Service Bulletin

DATE: APRIL 1992

REF: JD 03/92

XJ6 3.2 & 4.0

FIG. 1

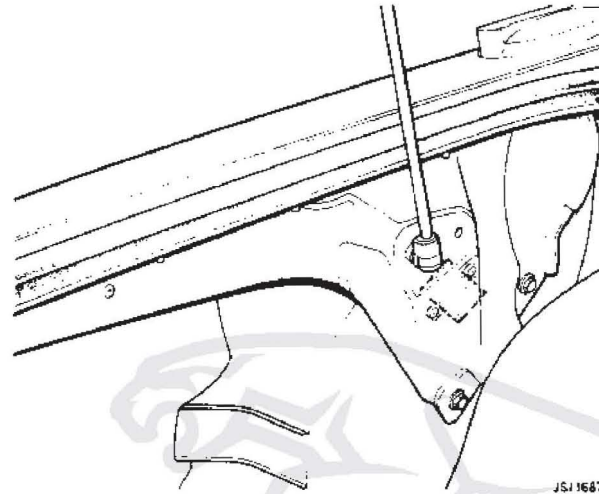
From VIN 179737 (92MY Facelift XJS), the stop light failure sensor module is located in the boot of the vehicle, attached to the inside of the boot side reinforcement panel (drainage channel) L.H. (Fig. 1).

FIG. 2

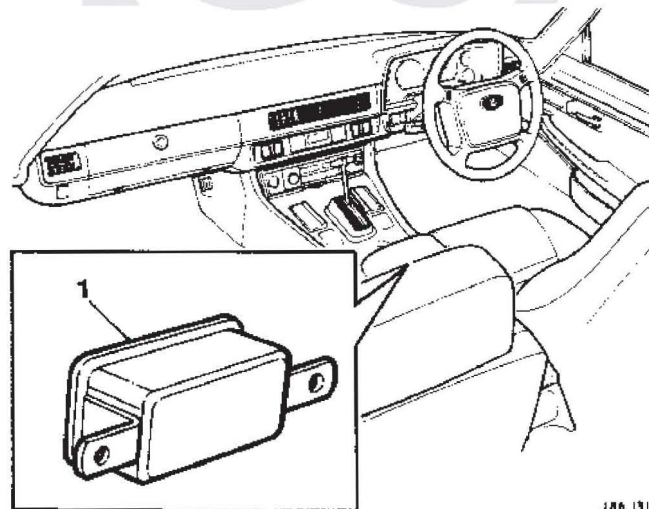
Prior to VIN 179737 (90MY XJS), the module is located beneath the centre console veneer finisher, attached to a bracket in front of the stowage compartment (Fig. 2).

FIG 1

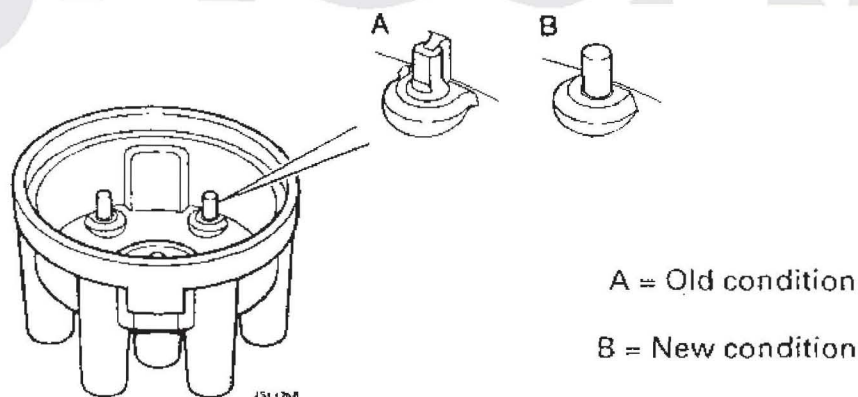
There has been a material change and revised electrode terminals introduced on AJ6 distributor caps.

Distributor assemblies incorporating caps to the revised condition were progressively introduced from 1st April 1992 production build, with the following safe engine numbers and VINs provided:

Please note that the part number for the distributor cap, JLM 150, remains unchanged and is fully interchangeable on vehicles with engine numbers prior to those listed above.

FIG 1

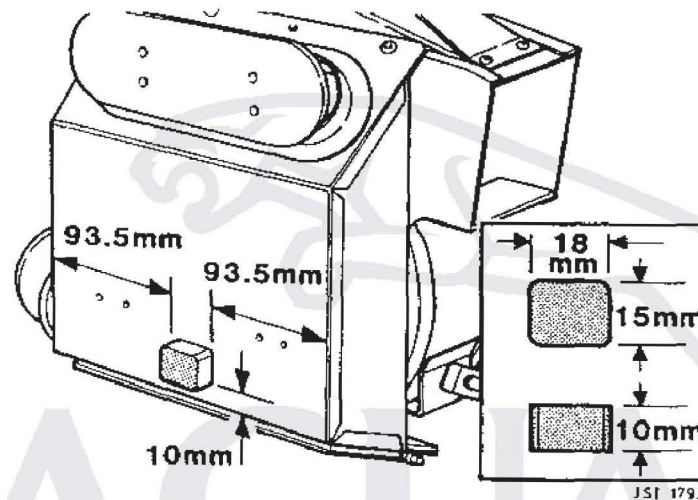
Isolated reports have been received concerning the driver's side blower motor recirculation flap being held partially open, due to the flap fouling the brake pedal switch mounting bracket.

To provide adequate clearance, the blower motor assembly is now positioned slightly forward by the introduction of a rubber spacer mounted on the rear face of the blower

Please note the "Butyl" tape remains flexible and may be re-used to secure the spacer to the new motor. (Refer to Fig 1 for position and dimension references).

In the event that a driver's side blower motor assembly requires replacement on a vehicle after the above VIN, Dealers should ensure that the spacer is removed and re-fitted to the new blower motor assembly.

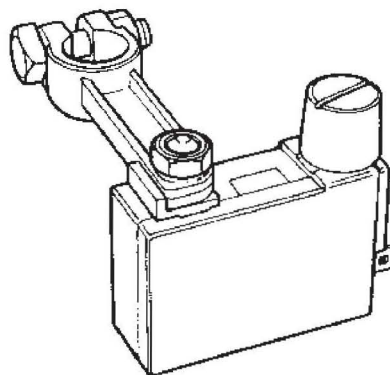
Owing to revised information, the torque figure for the coolant temperature transmitter to engine, XJS models, is 14,5 to 19,5 Nm.

The torque figure given in Service Bulletin JD 10/92 and Section 88 of XJS Service Manual, JJM 10 04 06/20, should be ignored and only the revised figure used.

FIG 2

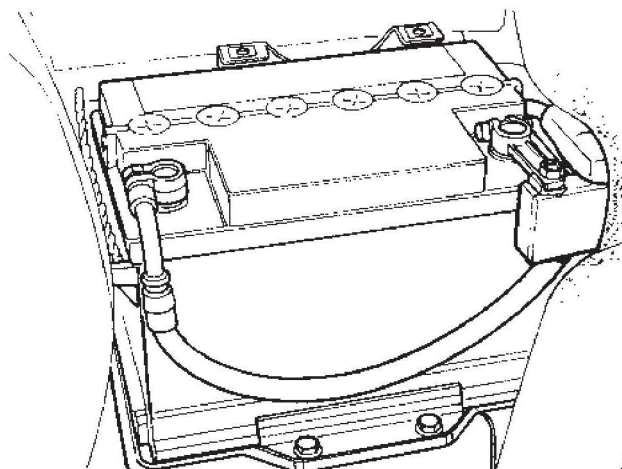
1. Open the boot and remove the battery cover, (see Fig 2).
2. Remove the negative lead from the battery.
3. Disconnect the transit relay from the battery.
4. Remove the white / yellow (W/Y) ignition wire from the transit relay.

FIG 3

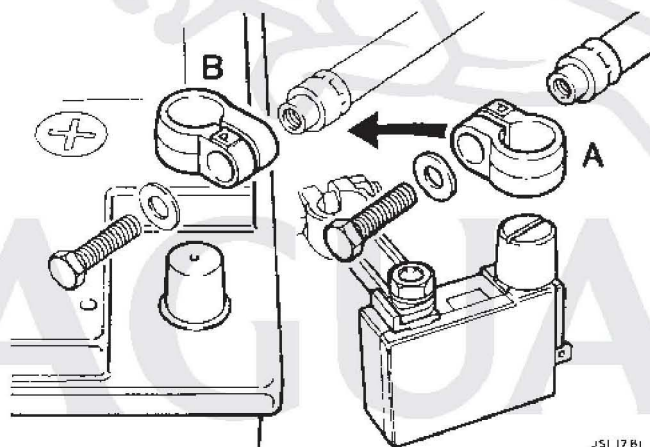
5. Remove the positive lead from the transit relay terminal post, (A, Fig 3).
6. Reverse the positive lead clamp and refit the clamp to the positive lead (B, Fig 3).

FIG 4

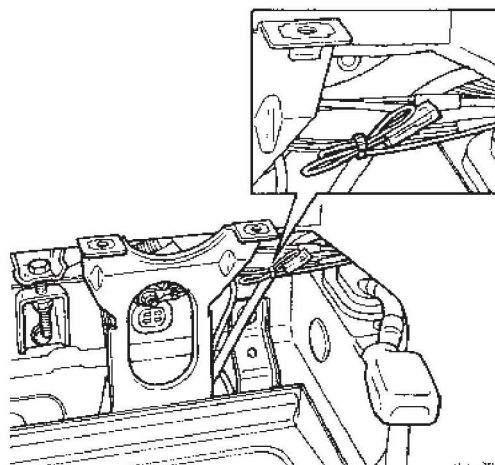
7. Displace the battery.
8. Tie back and secure the white / yellow (W/Y) ignition wire, (see Fig 4).

Fig. 1.

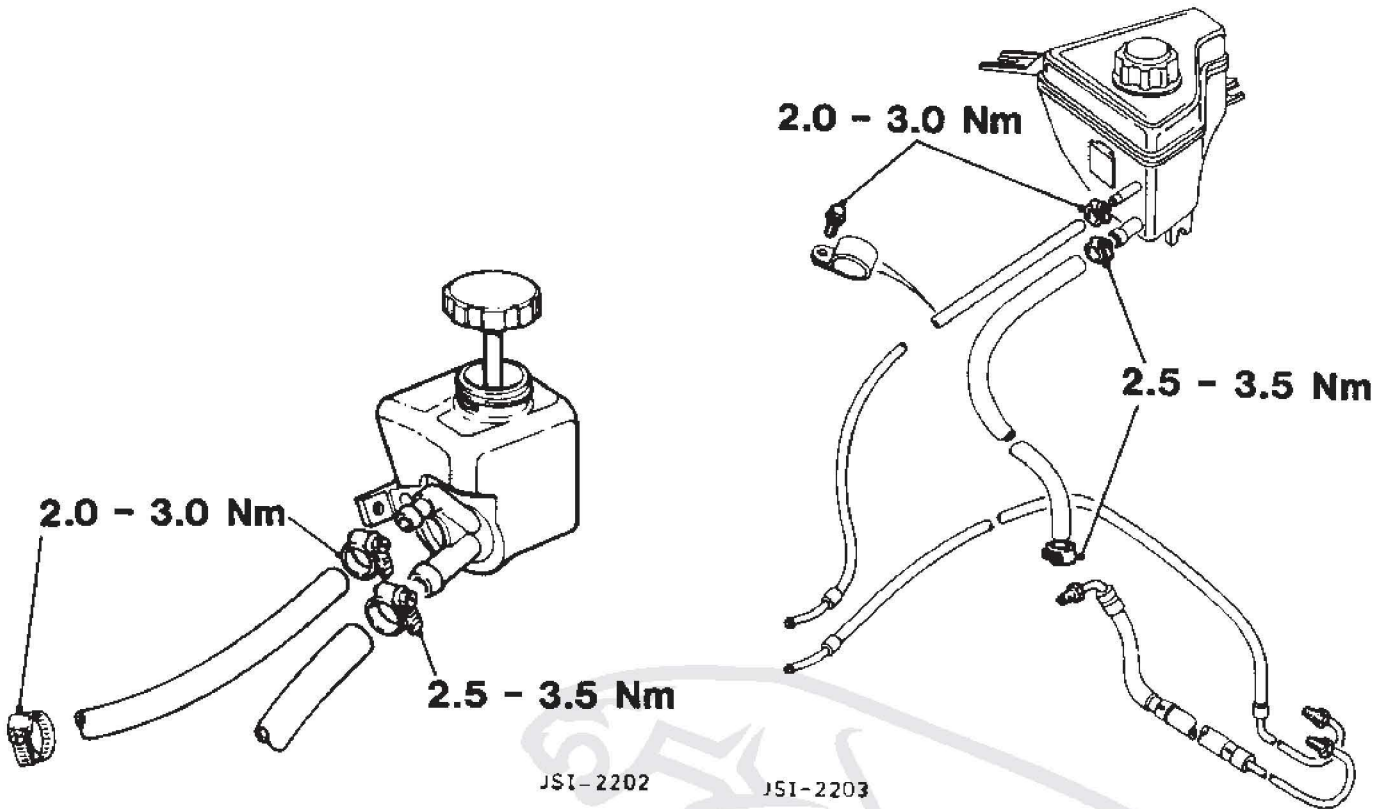
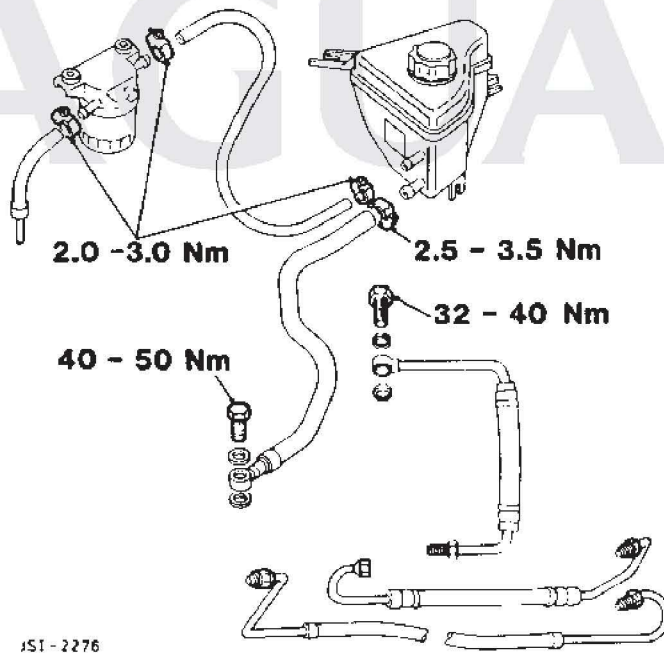
A revised tightening procedure for the worm-drive hose clips has been introduced in production from the VINs below; the same procedure, which involves a re-tightening after 30 minutes, must be followed in the event of any leaks in service:

The joints at which this pattern of clip are fitted are illustrated in Figs. 1, 2, and 3 overleaf, together with the torque wrench setting applicable to each clip.

- slacken off the clip concerned, just sufficient to allow a check that the hose concerned is fully home on the pipe stub.
- with the worm-drive hose clip in its original location on the hose, tighten the worm-drive clip to the designated torque wrench setting.
- **IMPORTANT:** WAIT 30 MINUTES. THEN RE-TORQUE THE WORM-DRIVE CLIP TO THE DESIGNATED SETTING. (DO NOT SLACKEN OFF THE WORM-DRIVE BETWEEN THE FIRST AND SECOND TORQUE CHECKS).

This re-tightening procedure takes up the relaxation which occurs in the rubber hose after the initial clamping, which otherwise may lead to a leak at the joint concerned if only a single tightening procedure were to be followed.
